RE: Swift Residence Swimming Pool Planning Board Review  
18 Quaker Meeting House Road, Armonk  
Town of North Castle  
Section 101.03, Block 3, Lot 28

Attached please find updated plans and additional information requested in response to the comments expressed in the Town's Consultant Engineer Review Memorandum dated June 23, 2022. A written response to each comment has been prepared and are provided below to assist you in your review:

SWIFT RESIDENCE POOL  
18 Quaker Meeting House Road  
Town of North Castle  
Westchester County, New York

TITLE: SITE PLAN

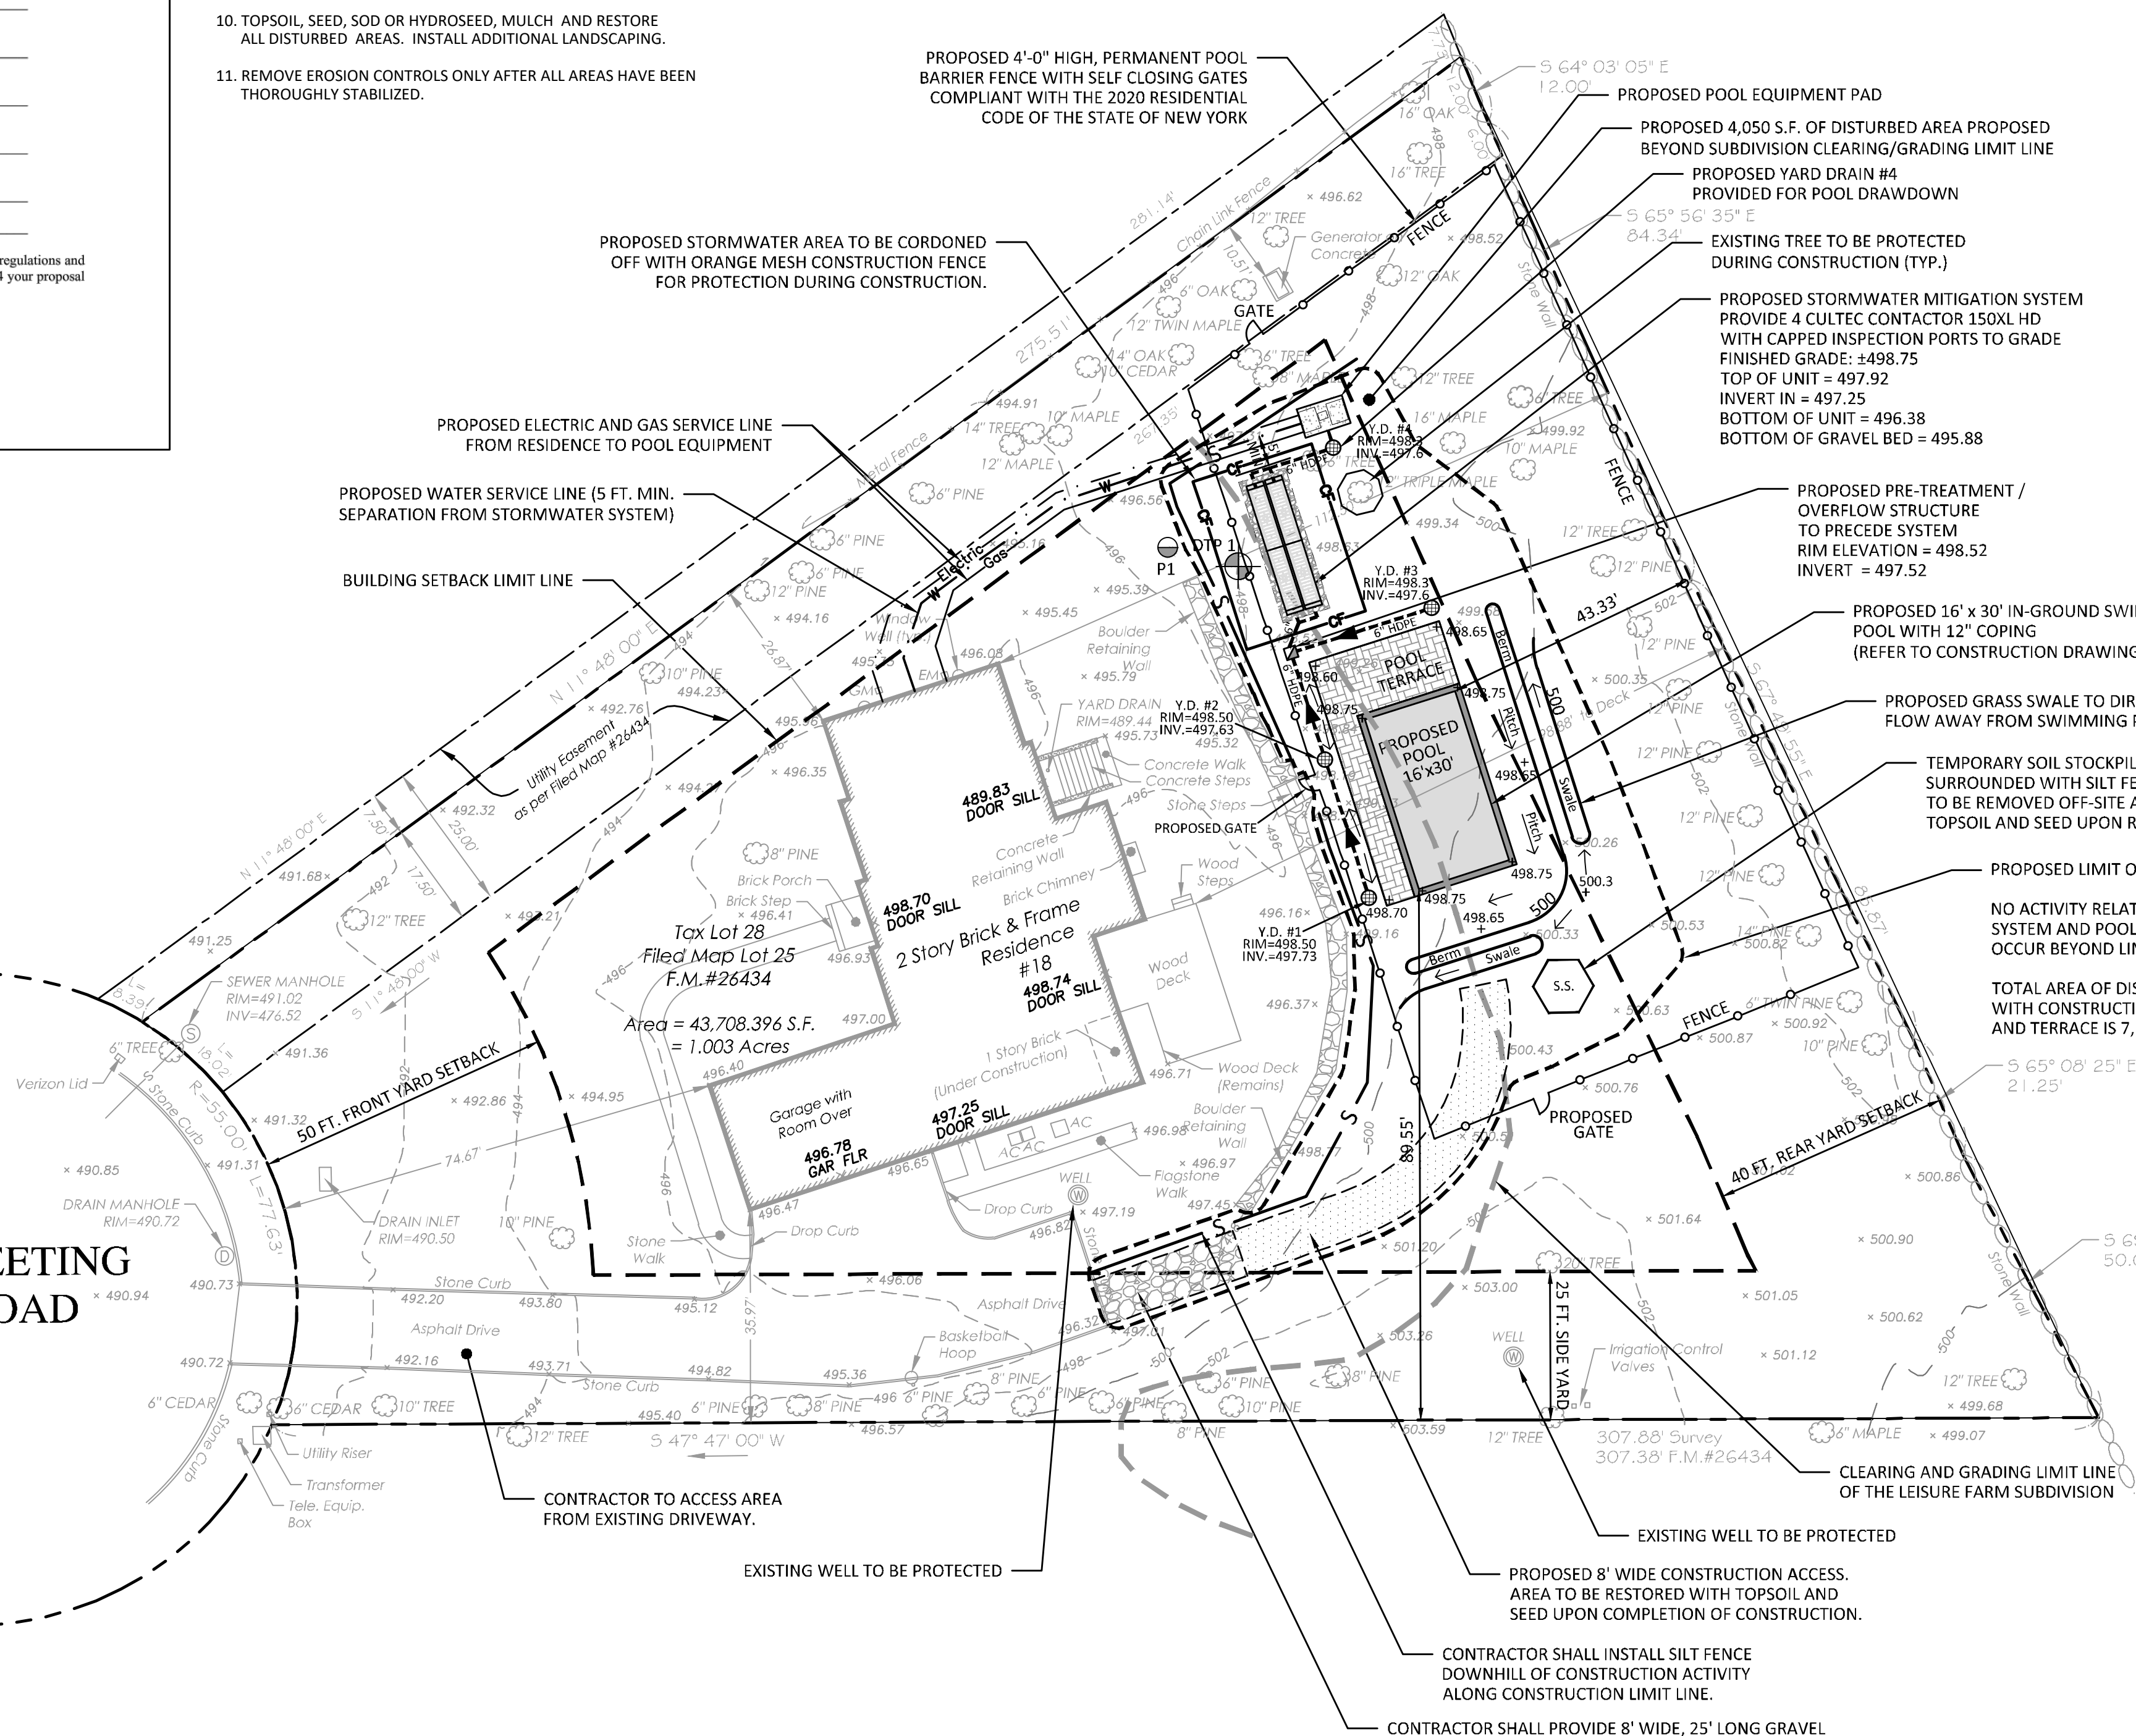
- 1. Filed Map #26434 – Leisure Farm Subdivision included a Clearing/Grading Limit which defined an area beyond which no clearing of trees, grading or alteration of contours or soil, filling or dumping or construction is permitted within Planning Board Approval. The Clearing/Grading Limit is depicted on the proposed Site Plan. The Planning Board will need to evaluate the proposed request to modify the limitation to accommodate the proposed pool and terrace. The applicant does not provide the actual area of the proposed modification, although it appears to be approximately 4,000 sf.*

2. *The applicant should provide the required pool winterization drawdown volume and confirm that the drawdown can be mitigated through the proposed infiltration system. Furthermore, the applicant should provide and label the connection between the pool equipment and infiltrator system.*

**Response:** The proposed plan will require the Clearing/Grading Limit line be modified to include the additional disturbance associated with the construction of the proposed pool, terrace, pool equipment and stormwater mitigation system. The plan has been updated to indicate the actual area of the proposed modification. A note indicating that the actual area is 4,050 sf has been added to the plan.

**Response:** The required pool winterization drawdown volume has been provided on the plan. The six (6) inch pool drawdown volume is 240 cf. The runoff generated by the net increase in impervious surface for the 25-year, 24-hour design storm event is 511 cf. The Stormwater mitigation system effectively discards 498 cf of runoff volume. The system is adequately sized for the pool drawdown volume.

SPECIAL NOTE:  
THE STORMWATER MITIGATION SYSTEM HAS BEEN SIZED TO ACCOMMODATE THE 25-YEAR, 24 HOUR DESIGN STORM EVENT. THE VOLUME OF RUNOFF GENERATED FROM THE 25-YEAR STORM EVENT IS 511 CUBIC FEET WHICH IS LARGER THAN THE 6" POOL DRAINAGE VOLUME OF 240 CUBIC FEET.  
THE MITIGATION SYSTEM EFFECTIVELY DISCARDS 498 CUBIC FEET OF RUNOFF VOLUME. THE SYSTEM IS SUITABLE FOR POOL DRAINAGE.
